PUBLIC HEARING/WORKING SESSION MEMORANDUM

PETITIONS #26-20 & #27-20

355 and 399 Grove Street

To: Neil Cronin, Planning and Development Department, City of Newton
From: Green International Affiliates, Inc. (Green)
Date: June 26, 2020
Project Name: Riverside Station
Project Number: Green No. 18078
Subject: Transportation Peer Review Response Letter

vhb Figure 1A
 Vehicular Volume Totals and Deltas
 Weekday Morning Peak Hour Traffic Volumes
**The Station at Riverside
 Newton, Massachusetts**

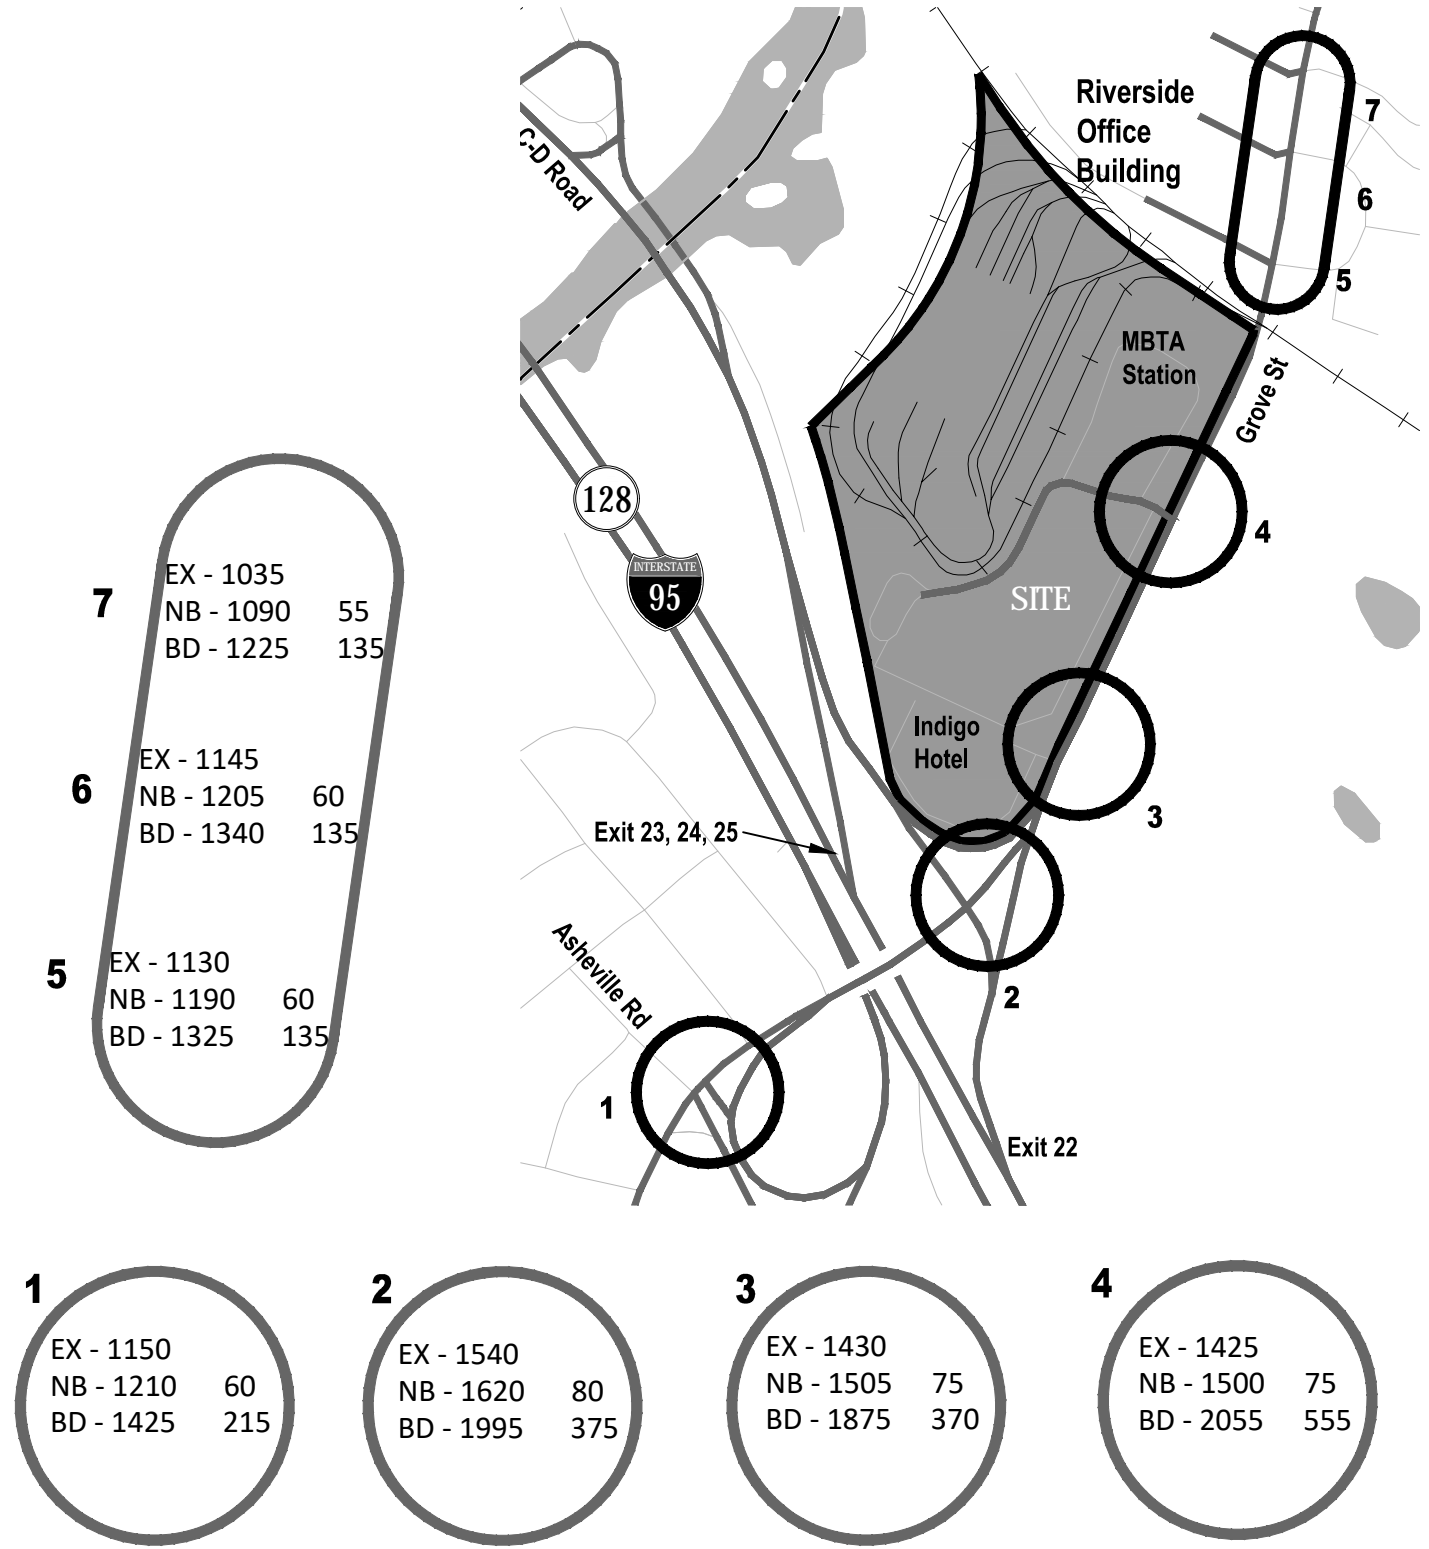
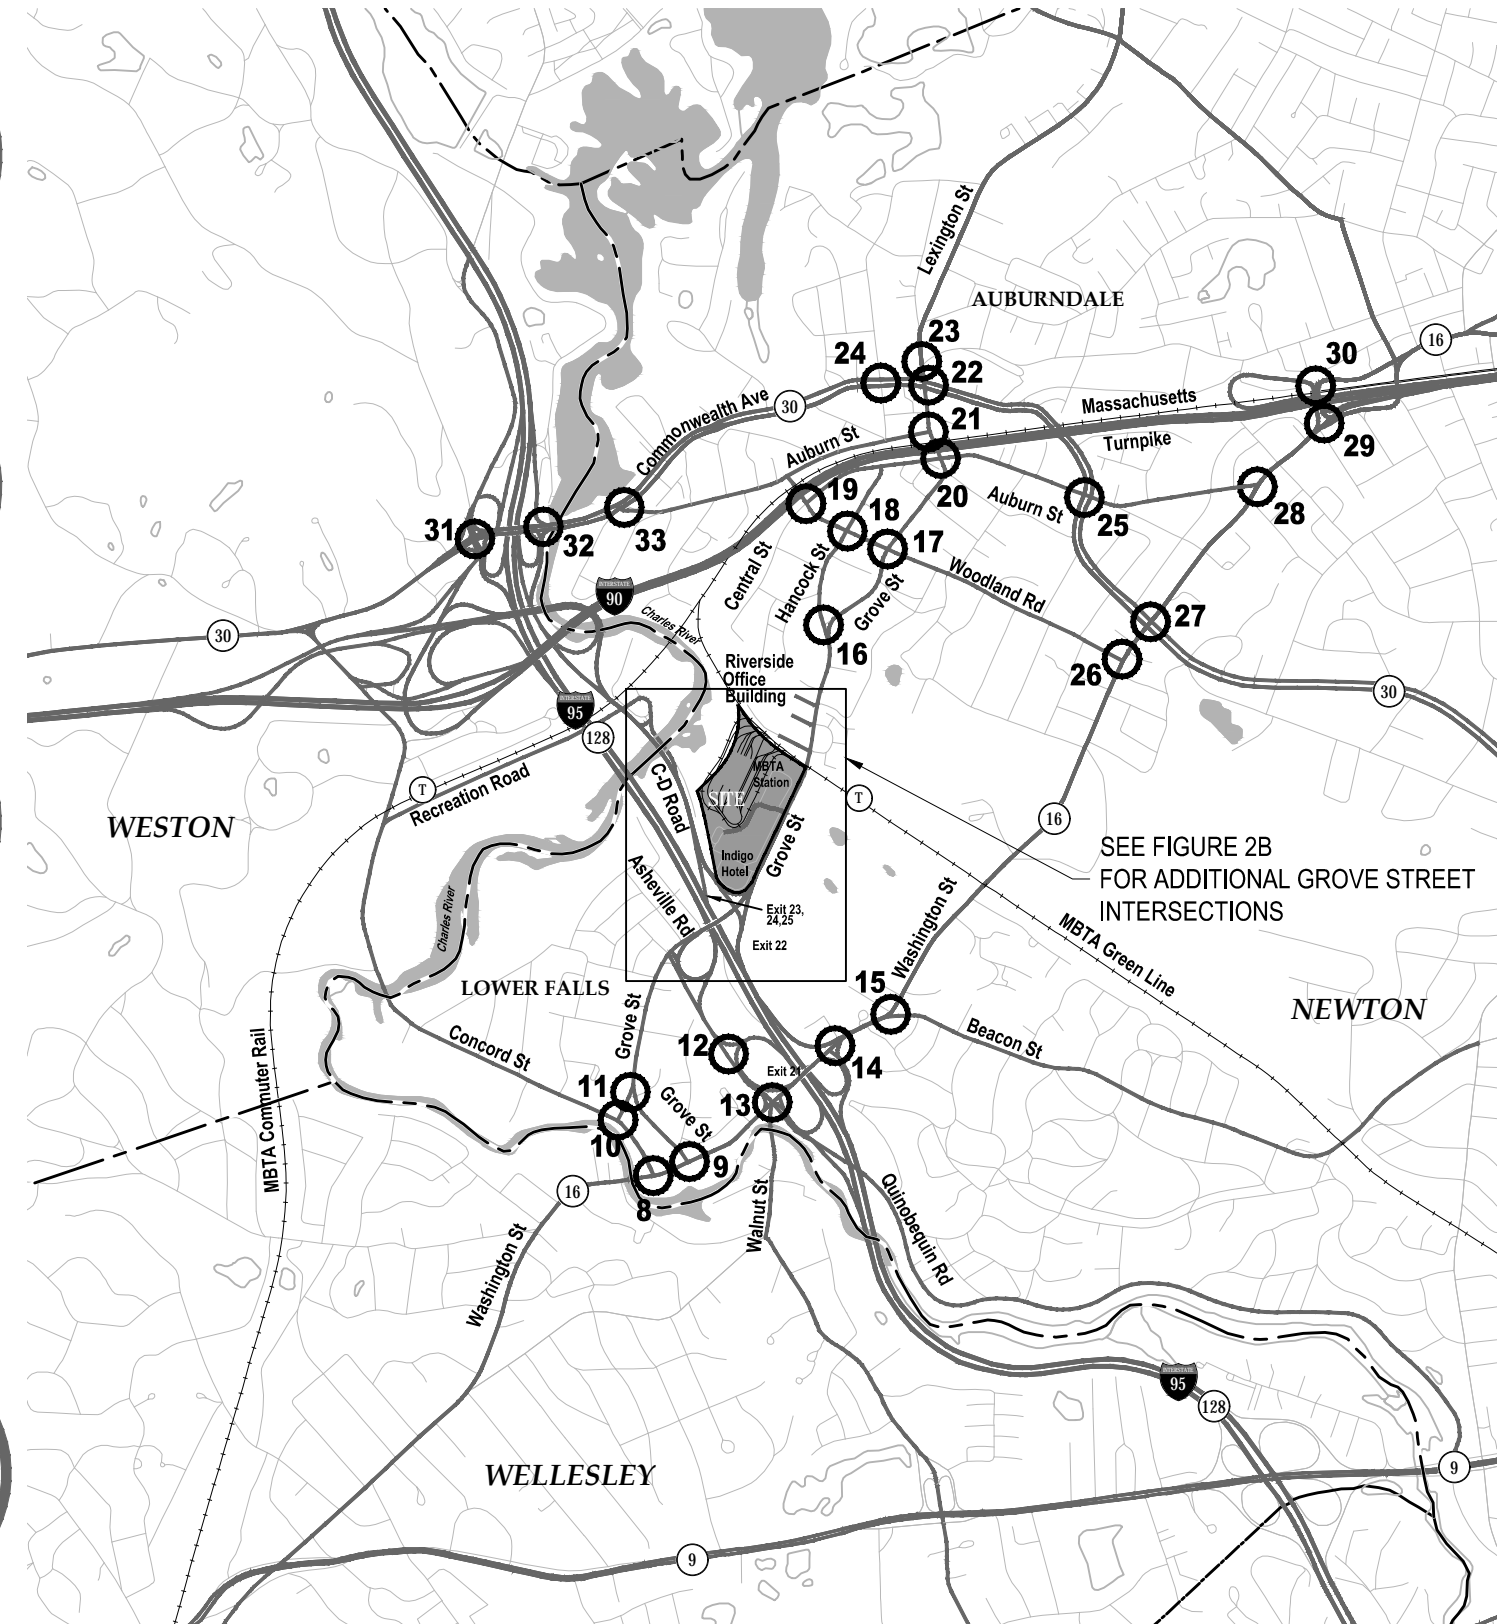
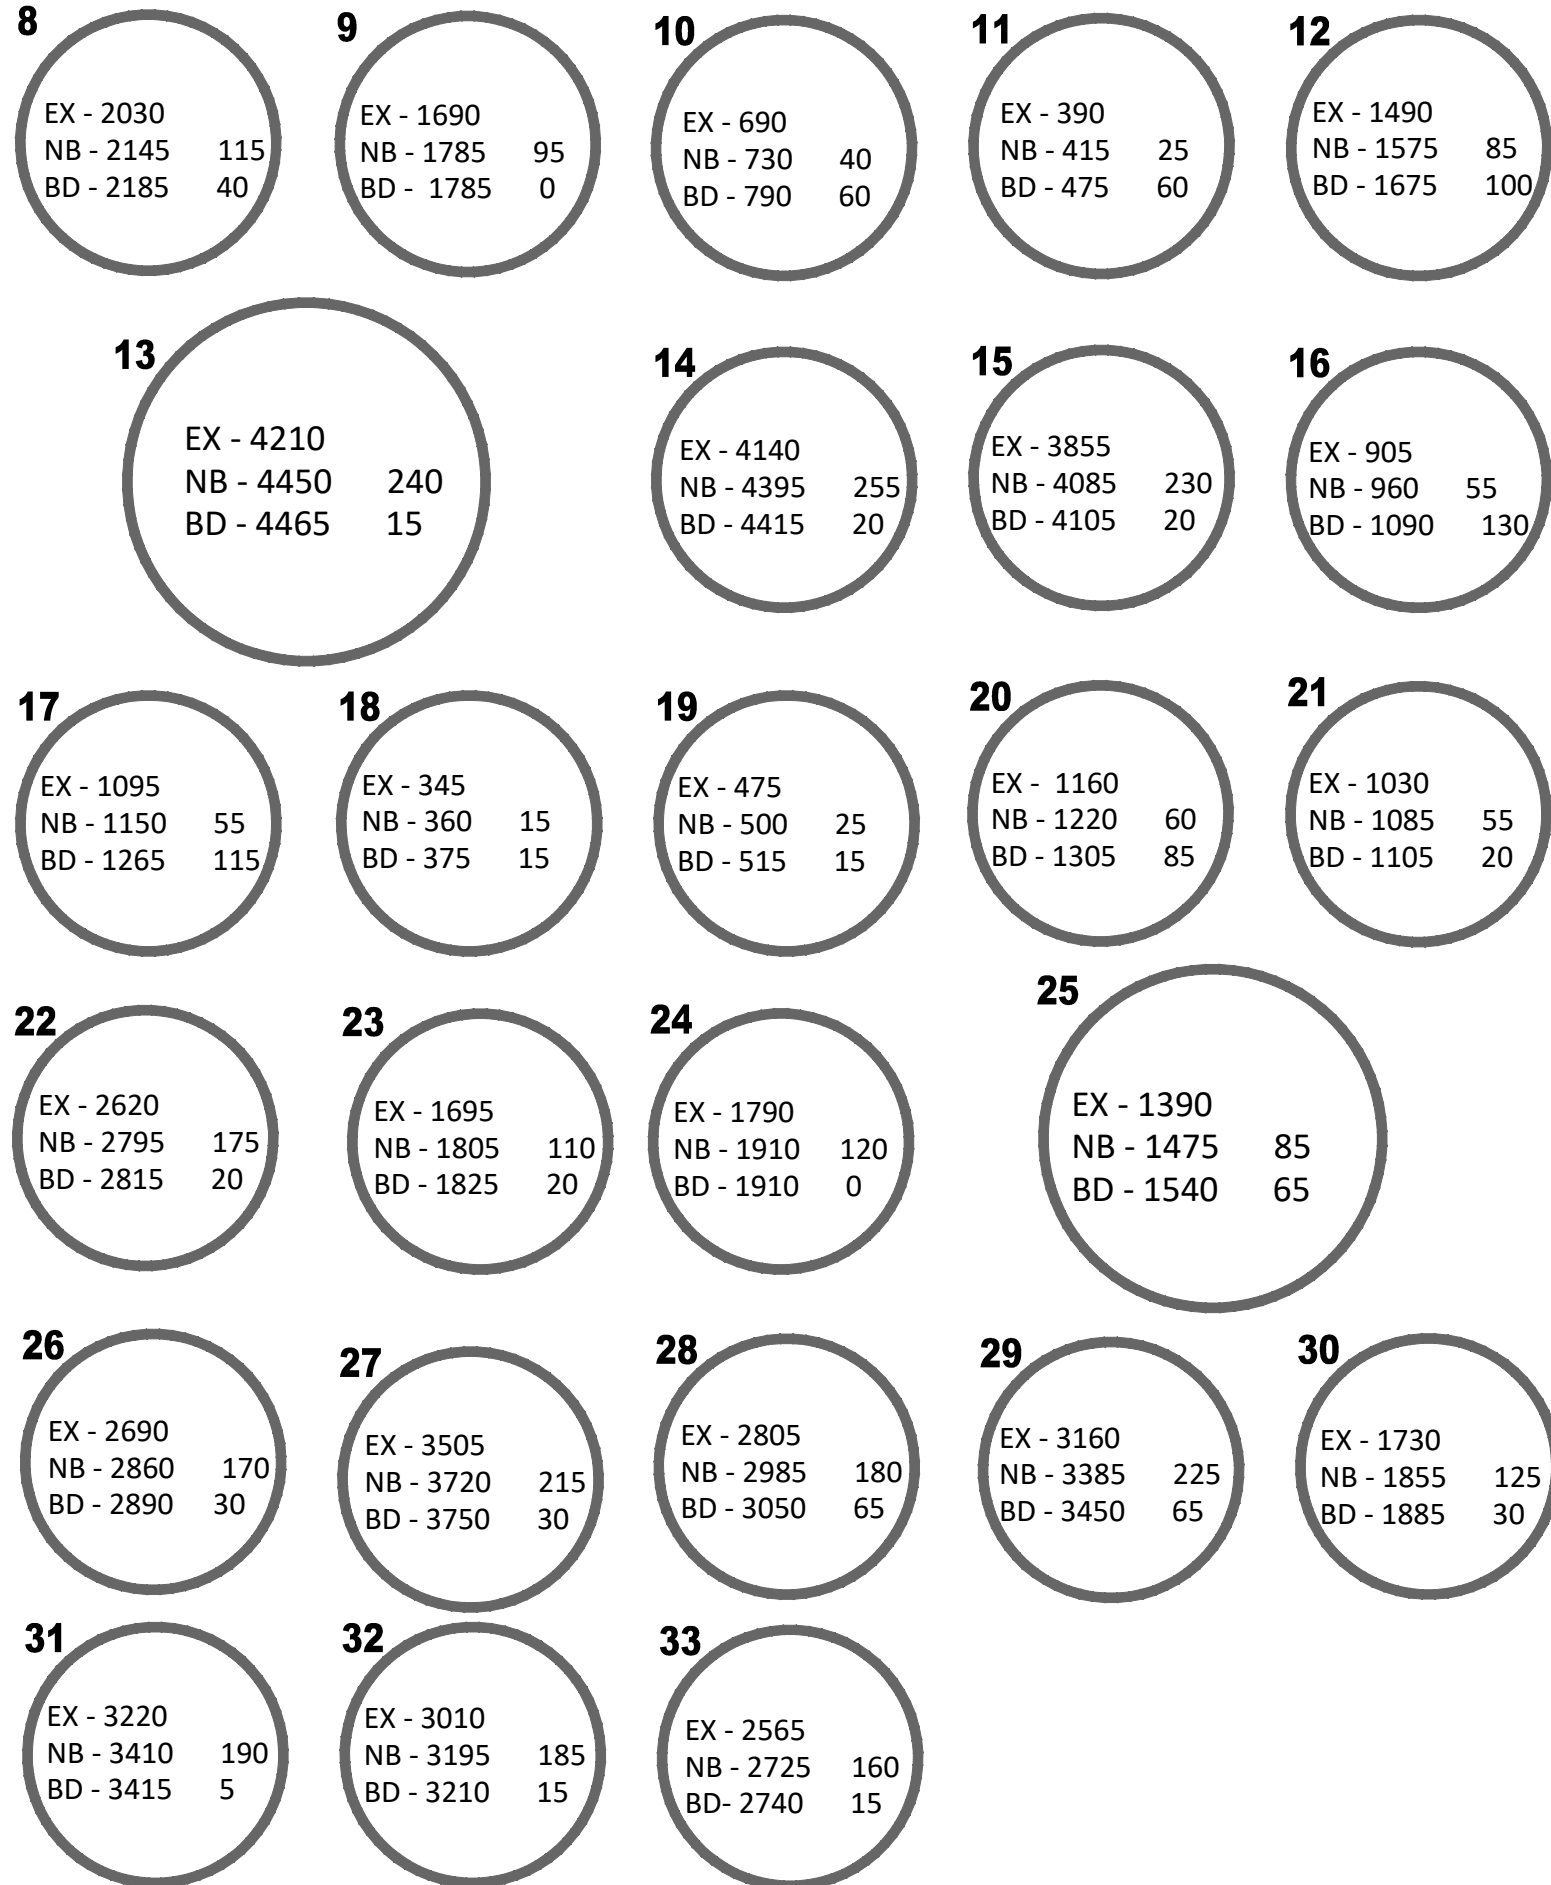
4. The memorandum provided a figure showing the increase in traffic at study area intersections during the peak hours. These trips represent the combination of all uses, residential, retail, office and hotel. While the individual uses have different trip distribution patterns, the figures provided show the combined effect on the roadway network. During the three peak hours, 210 – 220 new vehicle trips will be utilizing the new roundabout on Grove Street, 130-135 trips will be entering and exiting the site on Grove Street to the north, and a total of 370 – 415 trips will be entering from the Grove Street at Grove Street Extension intersection (including the trips utilizing the new roundabout). The developer should explain or correct the discrepancy shown on Figure 3B, where 10 vehicle trips disappear between Intersection 6 and Intersection 5, during the Saturday Peak Hour.
